Bulletin # SB-5K-001

SERVICE BULLETIN

Ride Manufacturer: Dartron Industries, Inc.	Affected Production Dates: All Cliff Hanger Rides
Ride Name: Cliff Hanger	Affected Serial #'s: All
Model #'s: All

Procedure For Visually Inspecting Cliff Hanger Bearing Base

PAGE 3

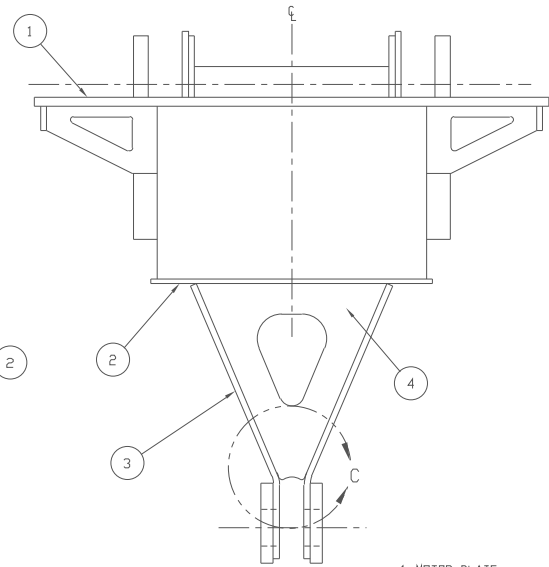
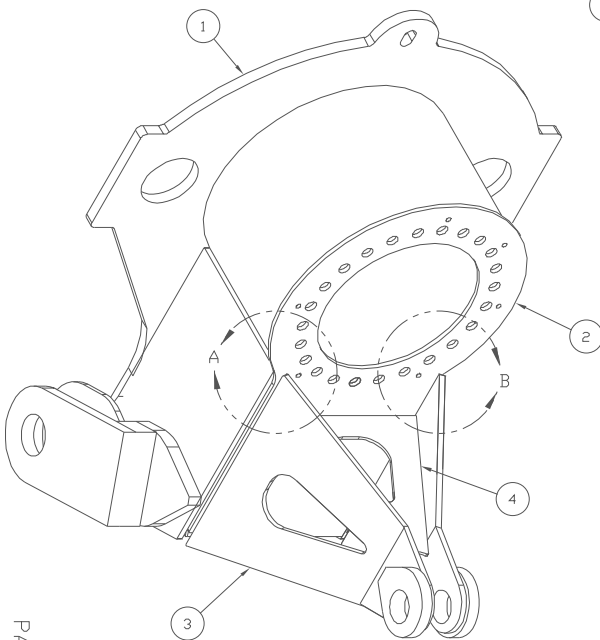
Step 3: Three areas must be visually inspected. Those areas are shown on Page 3 as Detail A, B and C.

Step 5: Visually inspect the three areas for cracks or broken paint.

Step 6: If broken paint is found, the paint must be removed to allow a more through visual crack inspection.
